VUSTA SEMINAR 23 November 2011

ICEM – International Centre for Environmental Management

# Overview of the compliance report purpose

### estimation of Mekong sediment loads & trapping

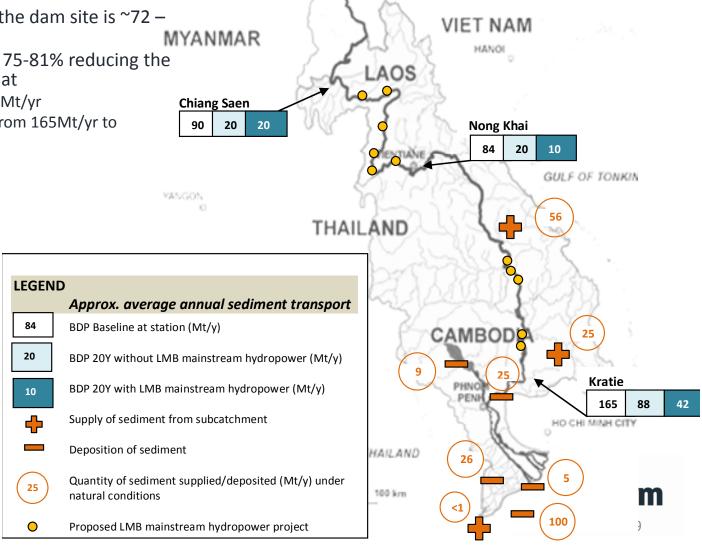
- The Poyry Report incorrectly states:
  - "The total sediment load between Manwan Dam at the Chinese Border and Pak Chom is around 5% of the total sediment load arriving at the Mekong Delta. Therefore in the theoretical case if 100% of the incoming sediments at Xayaburi are trapped, the total sediment loads at the Mekong Delta would be reduced by a maximum of 5%."
- The Xayaburi project would have an impact on the total sediment load arriving at the dam, not just the sediment originating downstream of the Chinese cascade.

total sediment load at the dam site is ~72 – 90 Mt/yr.

TE (Chinese cascade) ~ 75-81% reducing the sediment load arriving at

- Xayaburi HPP to ~20Mt/yr
- Mekong River load from 165Mt/yr to 88Mt/yr.
- Therefore, if the Xayaburi HPP was to block 100% of this remaining load, this would amount to a further 25-30% reduction of the remnant sediment load of the Mekong River, which is more than 5 times higher than the estimate in the Poyry report.
